L-2022-108  
10 CFR 54.17

St. Lucie Nuclear Plant Units 1 and 2  
Dockets 50-335 and 50-389  
Renewed Facility Operating Licenses DPR-67 and NPF-16

**SUBSEQUENT LICENSE RENEWAL APPLICATION - AGING MANAGEMENT REQUESTS FOR  
ADDITIONAL INFORMATION (RAI) SET 2 RESPONSE**

**Figure 1: St. Lucie Units 1 and 2 RPV Support Shoe Socket and Slide at Nozzle Support**

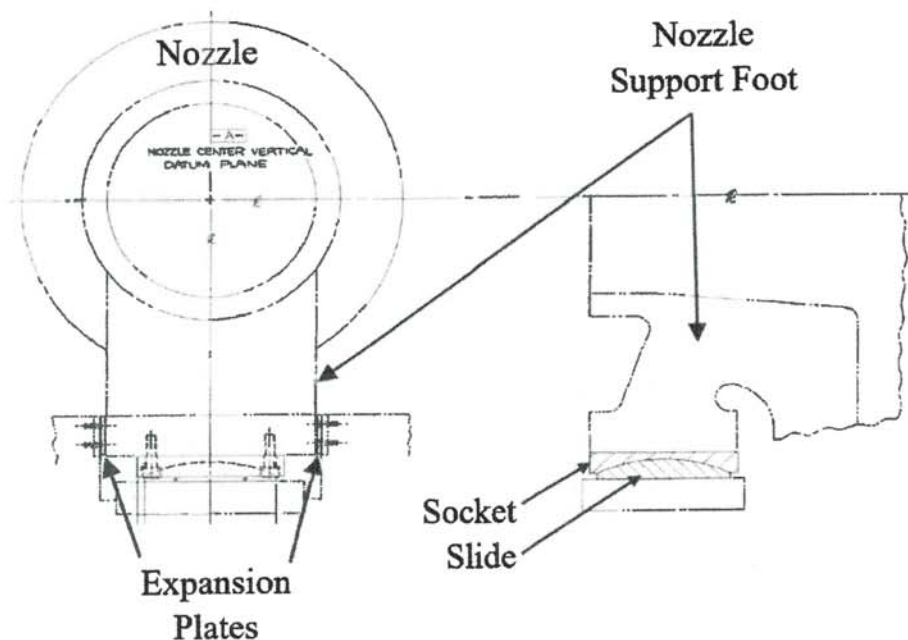
The RPV sliding plates are identified as ASTM B-22 Alloy E, a manganese bronze alloy, lubricated with Lubrite type AE-2 lubricant. There is not an identified radiation embrittlement basis provided for this manganese bronze alloy component. Additionally, the basis for inclusion of gamma ray heating that could increase the temperature for the assembly, of this manganese bronze alloy component and for its Lubrite lubricant is not clearly identified as it relates to the 300°F.

1. Identify the radiation embrittlement basis provided for this manganese bronze alloy component.
2. Clarify whether the manganese bronze component and its Lubrite lubricant has been evaluated for inclusion of gamma ray heating.
3. Identify necessary updates of pertinent areas of the SLRA reflecting this RAI input or justify PSL position for not updating.

1. The RPV slide (circular convex plate) and expansion plates are ASTM B-22 Alloy E, a manganese bronze alloy. The socket and slide design allows the thermal expansion and contraction of the RPV during heatup and cooldown. As illustrated in Figure 1 below, the slide experiences compressive loads during normal operating conditions, and friction forces at the socket-slide interface. Similarly, the expansion plates on the side only experience compressive loads and friction forces during thermal expansion of the RPV. One of the key factors for stress corrosion cracking (SCC) to occur is a high level of sustained tensile stress. Since the slide and expansion plates are mainly in compression, SCC or any other crack growth mechanism is unlikely to occur. Even if a crack were to occur in the slide or expansion plates, they will likely remain in place and continue to perform their intended function. Therefore, an analysis of the radiation embrittlement of the manganese bronze alloy for the slide and expansion plates is unnecessary.
